ADDENDUM NO. 1

April 23, 2024

Whiteland Community High School Phase 2A
300 E. Main Street
Whiteland, IN 46184

This Addendum consists of Pages ADD 1-1 through ADD 1-2 and attached Specification Sections 01 21 00 – Revised Contract Allowances, Logistics Plan, Guideline Schedule, and Lancer Associates Architecture Addendum No. 1, dated April 23, 2024, consisting of 63 Pages, Specification Sections 11 68 33 – Field Events & Athletic Equipment, 32 18 23 – Track Surfacing Latex System, 32 31 13 – Chain Link Fencing and Gates, 33 14 17 – Site Water Utility Service Laterals, 33 42 00 – Stormwater Conveyance, and Drawings 100, 210, 302, 303, 400, 401, 402, 403, 500, 501, 600, 601, 700, 900, 901, 902, 903, 904, 1004, L101, L102, L201, L202, L402, ES102, ES103, and ES301.

SHEET 904

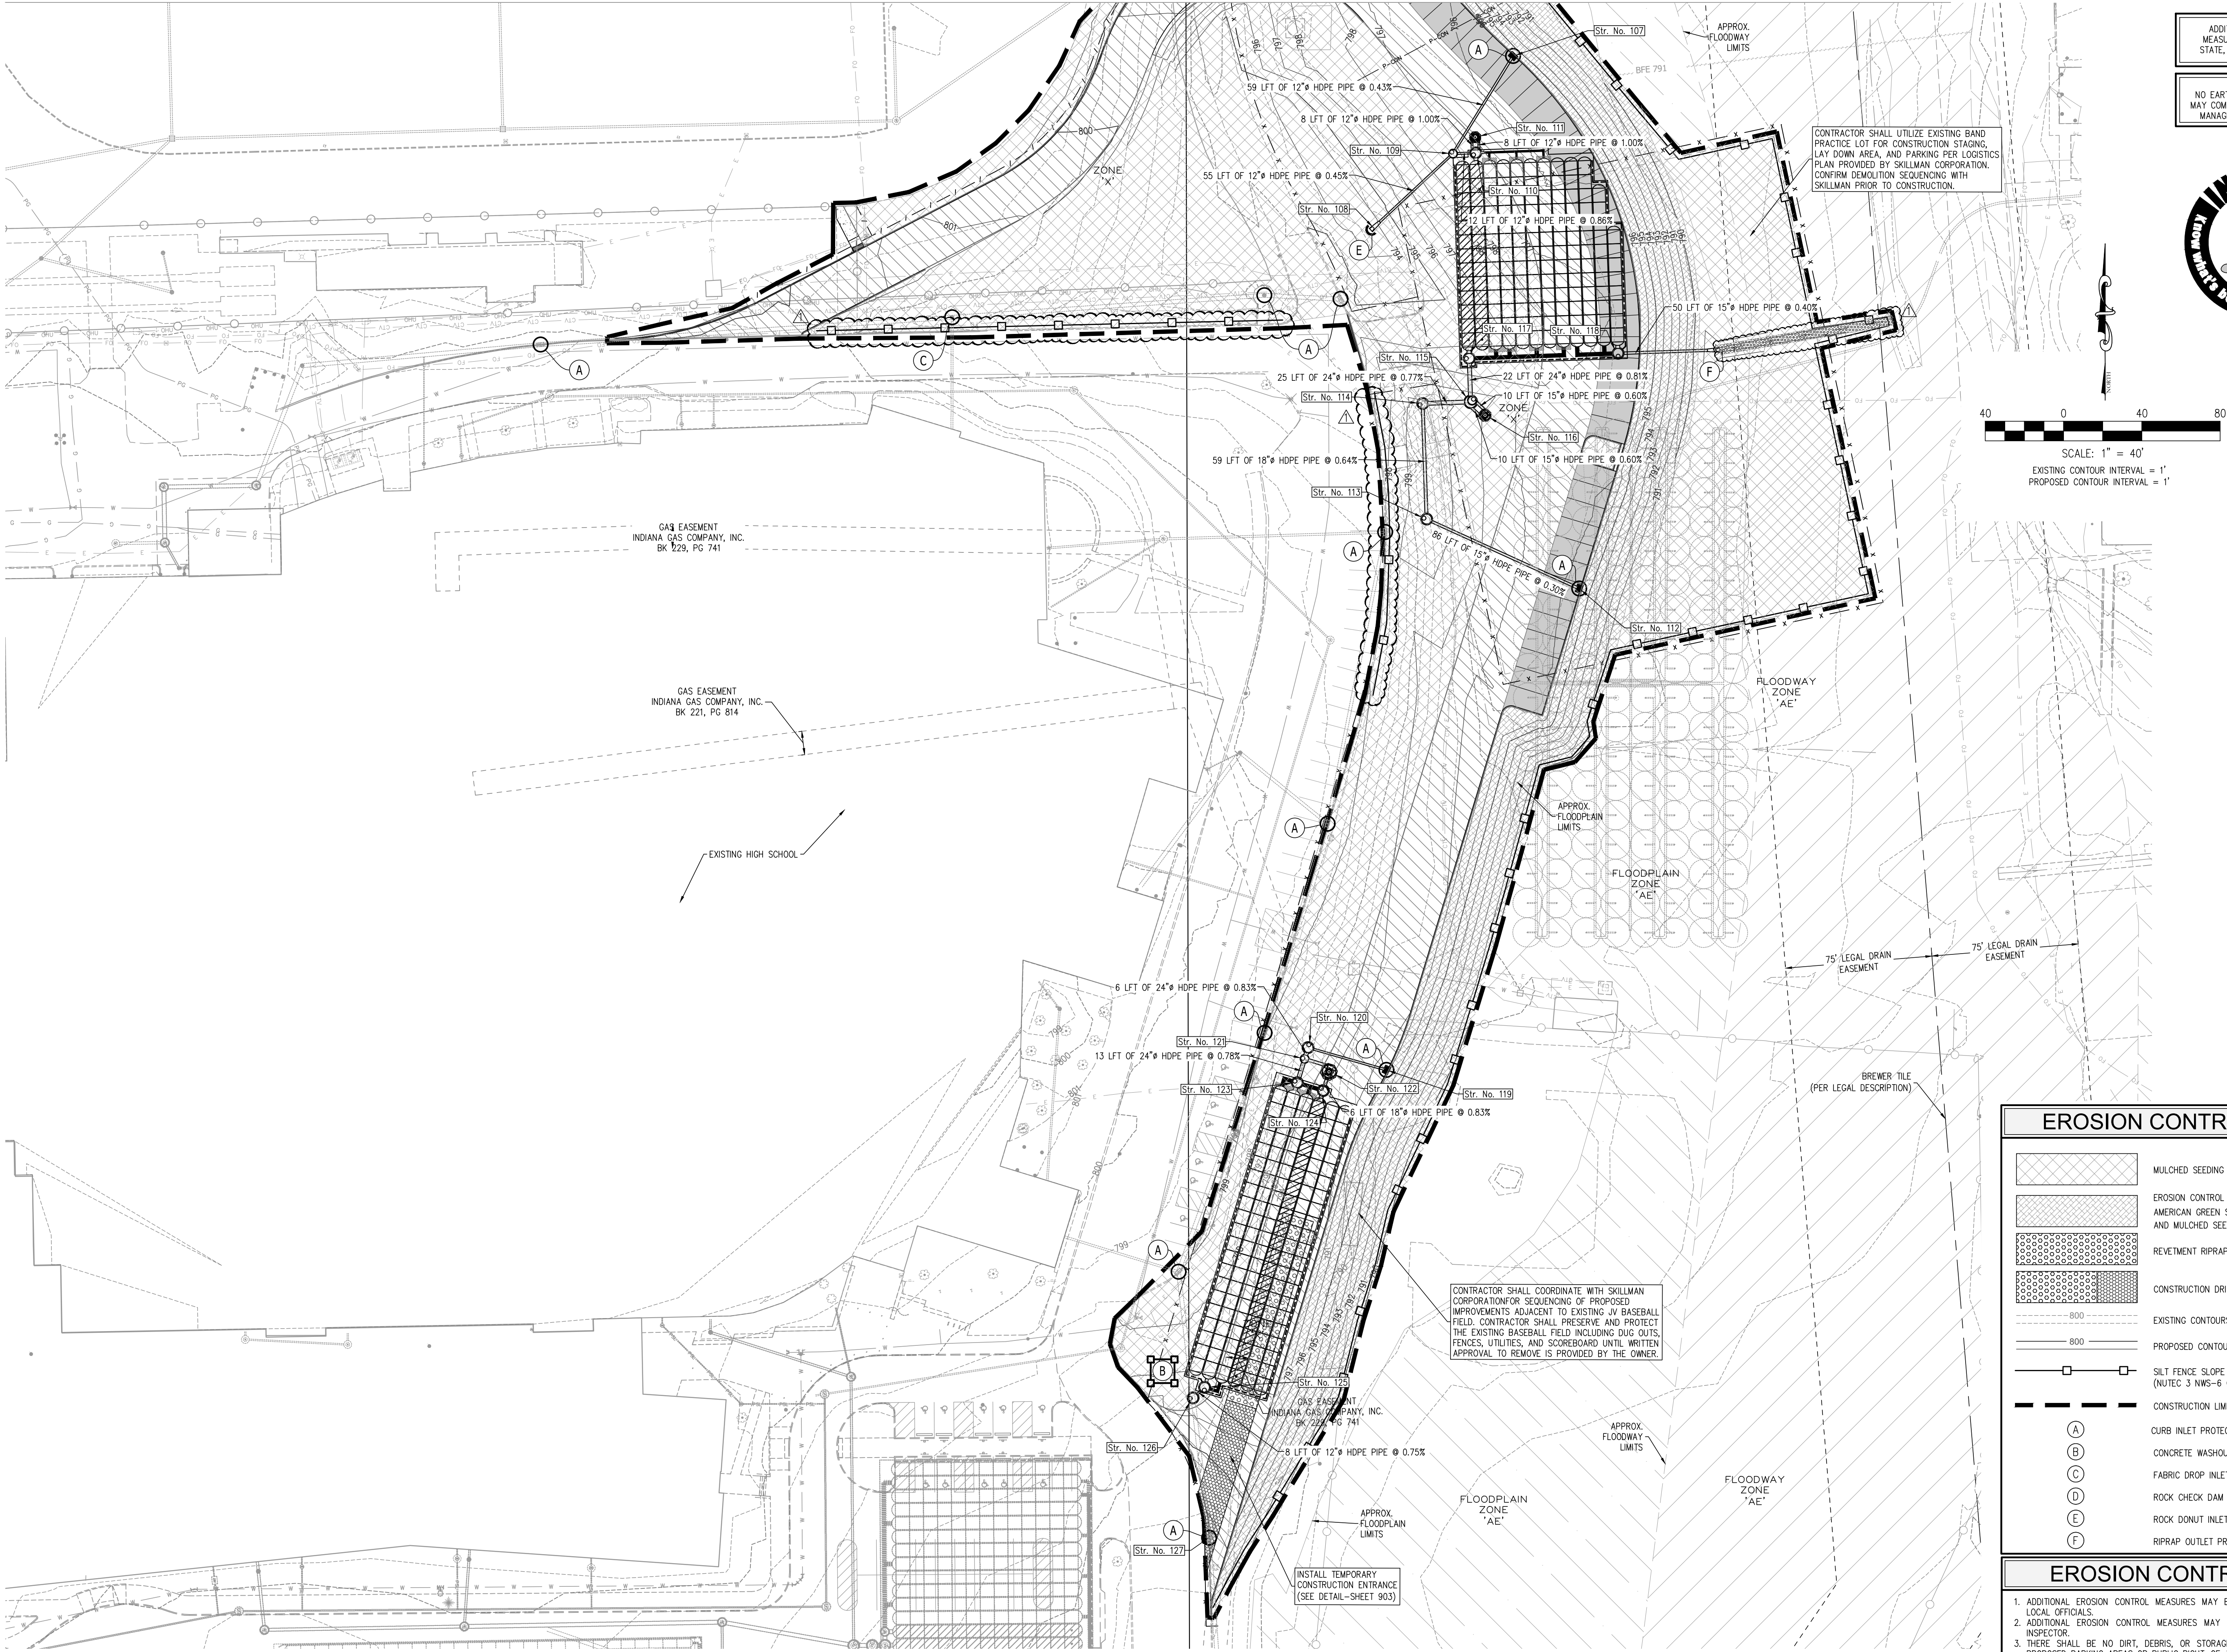
- o Extended riprap apron length from Str. No. 118 outlet pipe in response to Johnson Co. Surveyor's Office review comments.
- o Added silt fence along the north and east sides of the existing drive near the northeast corner of the high school.

SLOPED & FLARED
HEADWALLS FOR
12" TO 27" PIPE

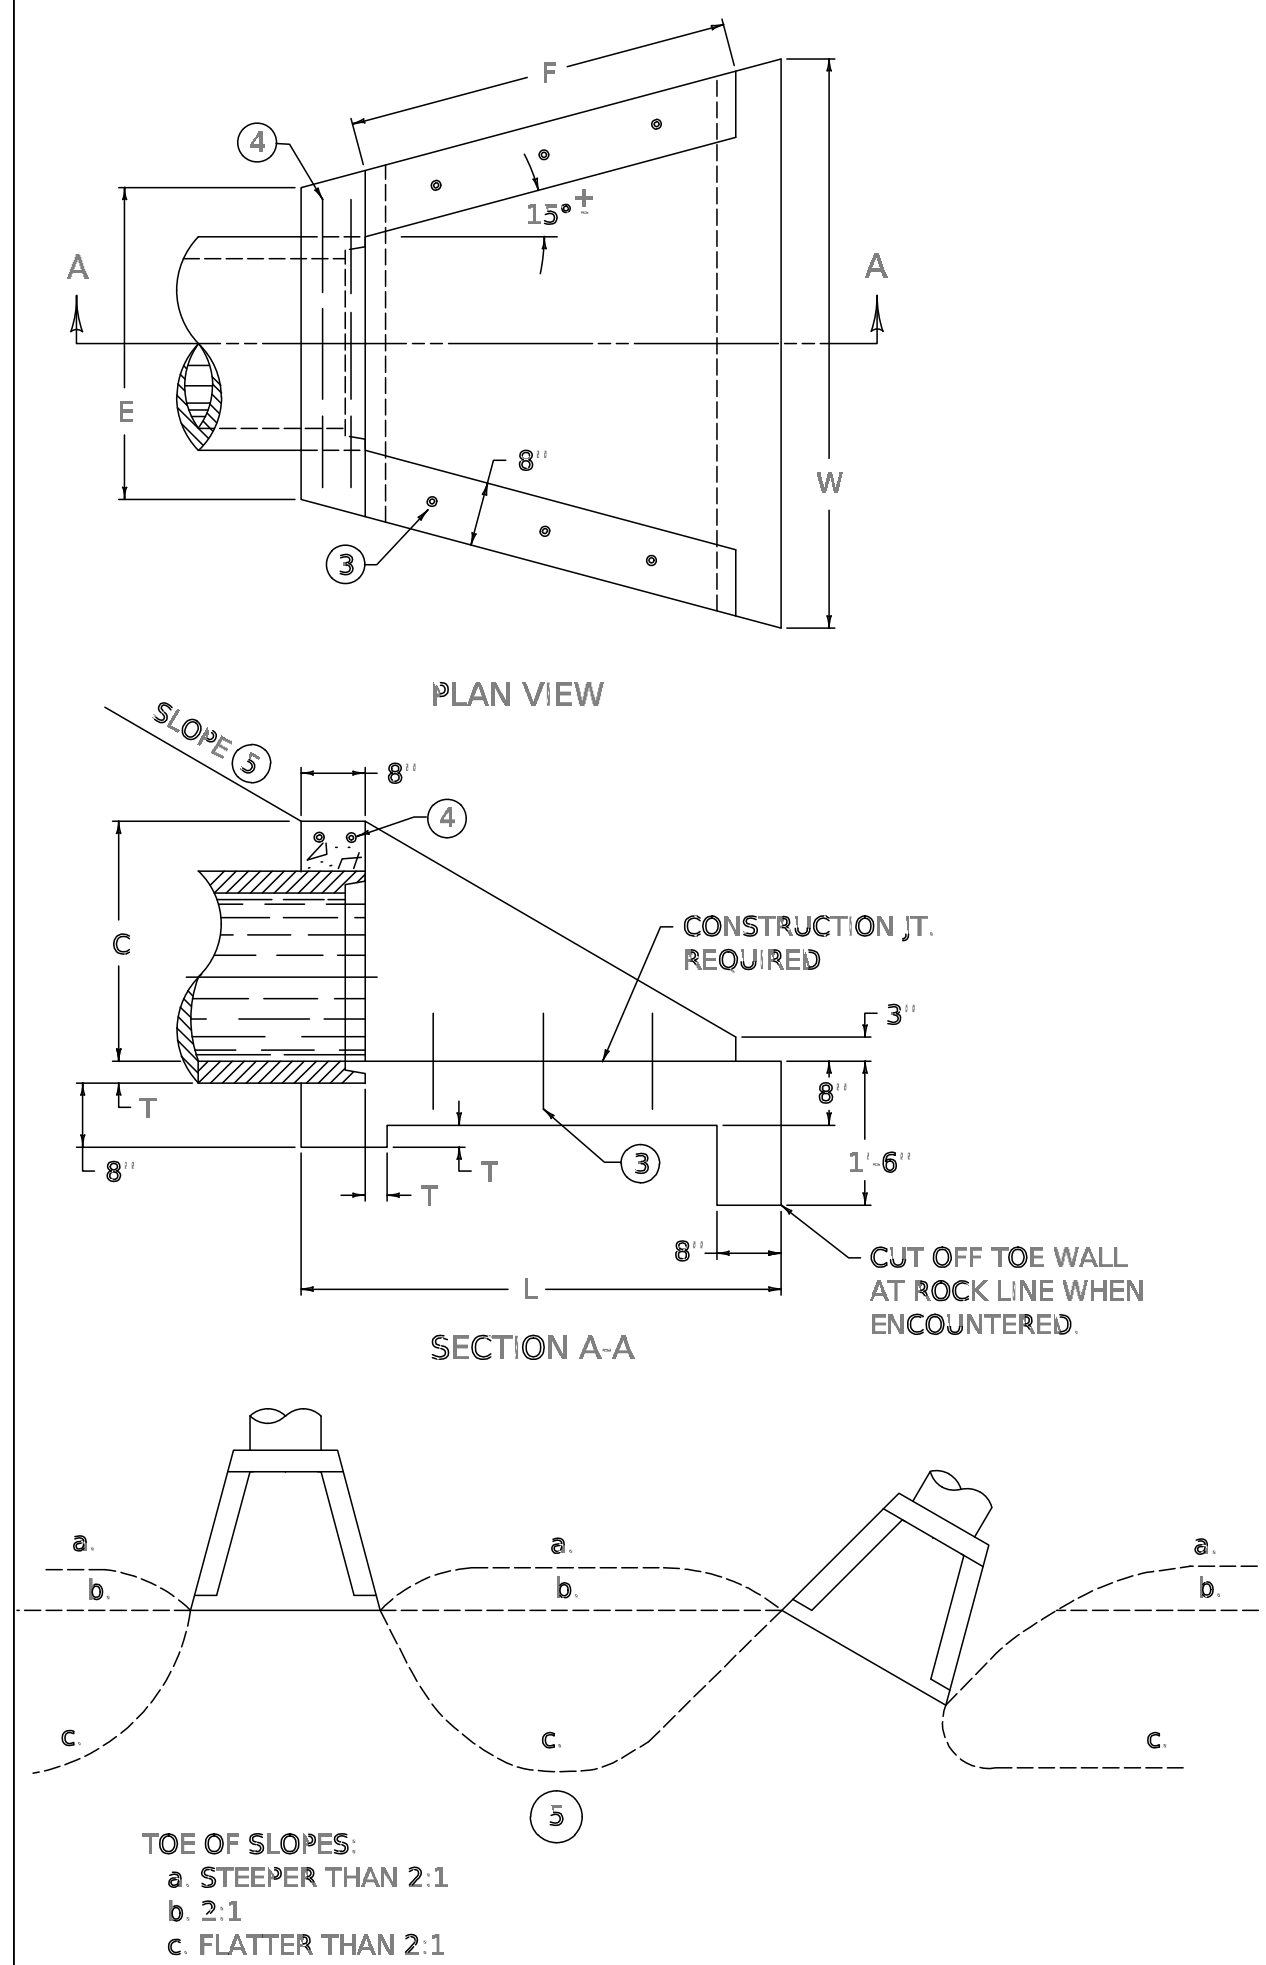
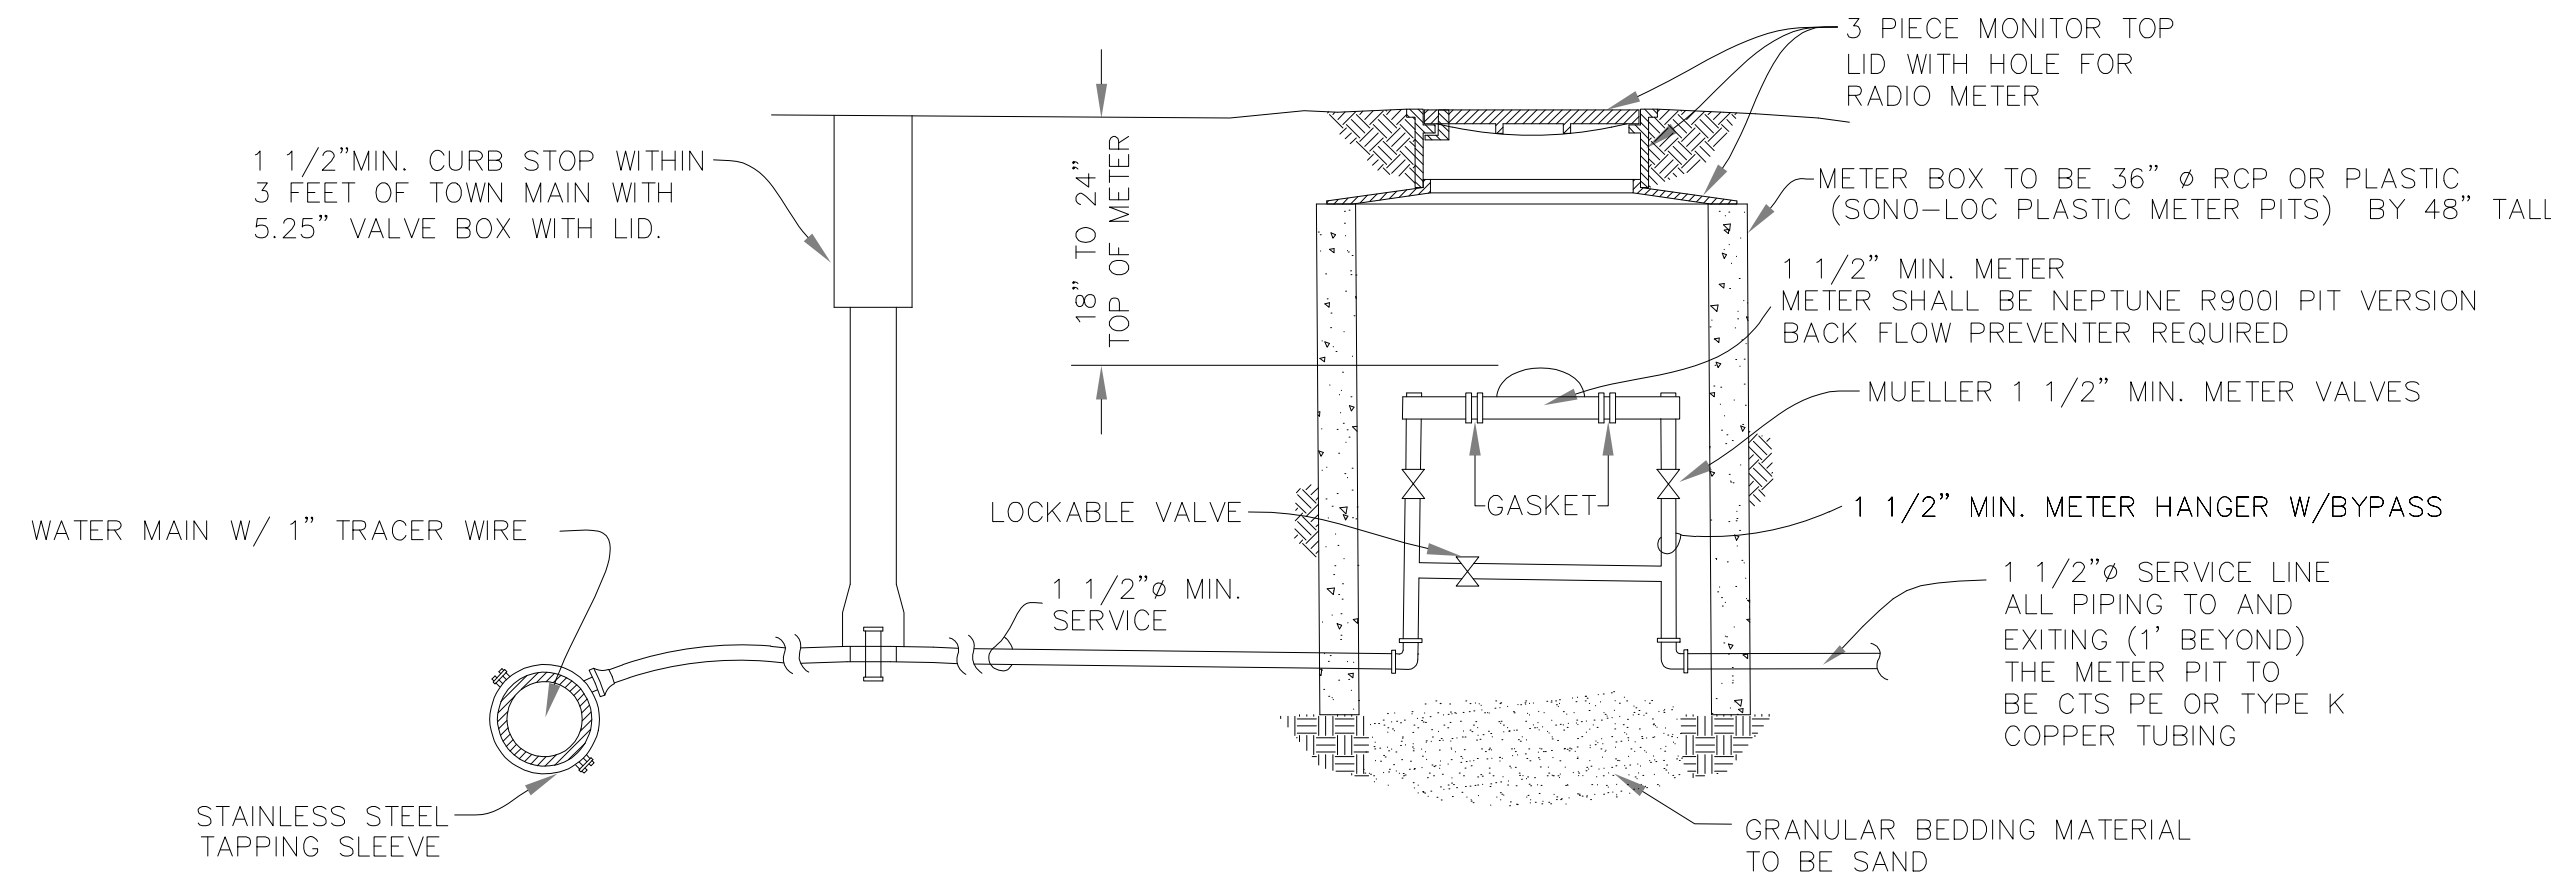
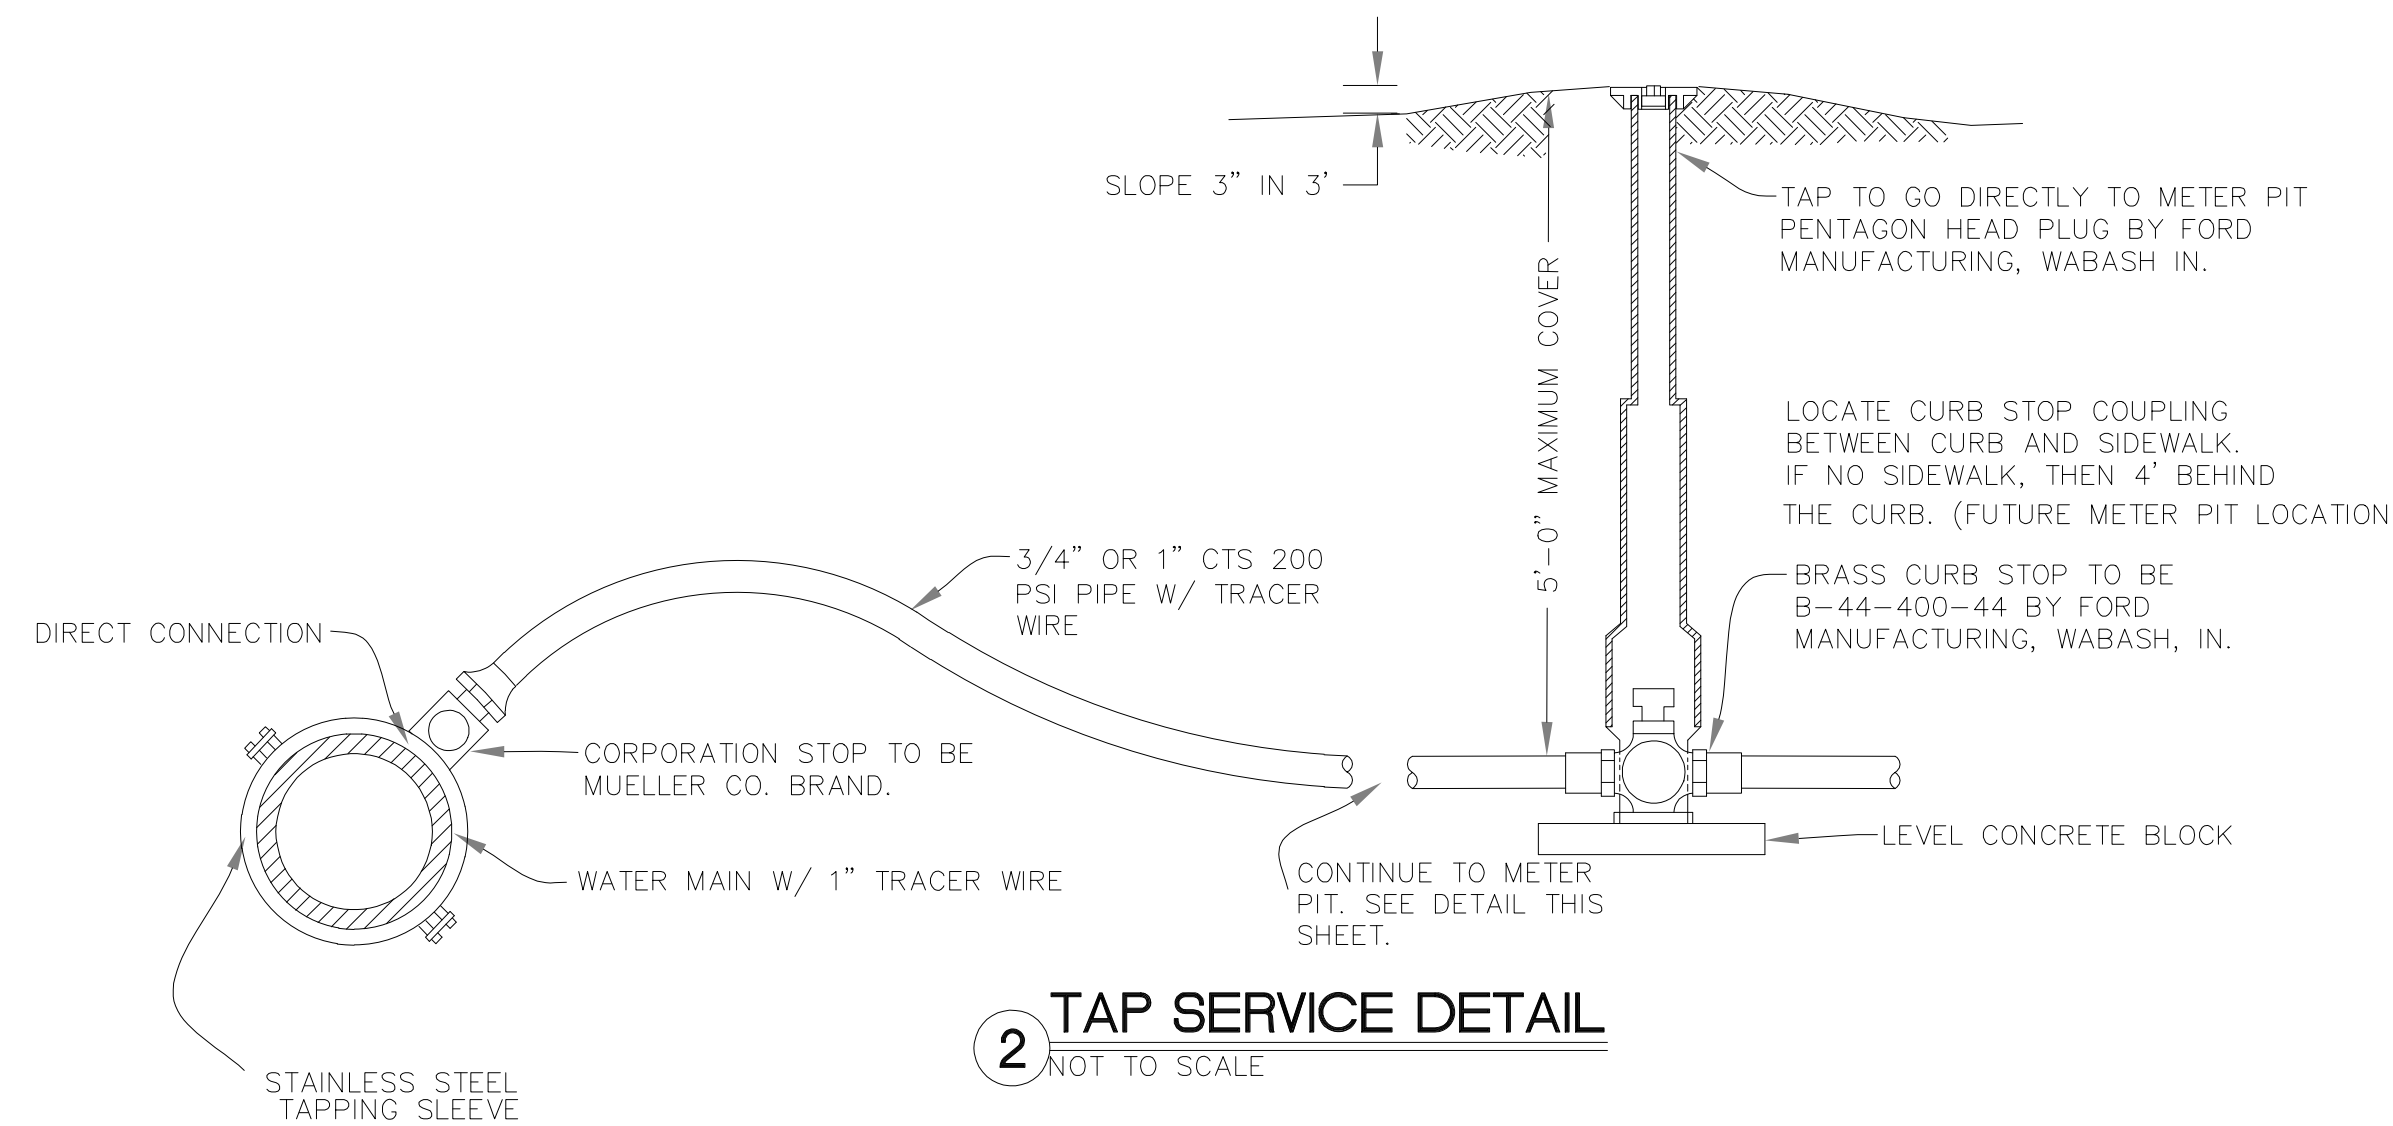
- o Add sheet to include details for concrete headwall, water service tap, and 1 ½" & 2" commercial water meter pits.
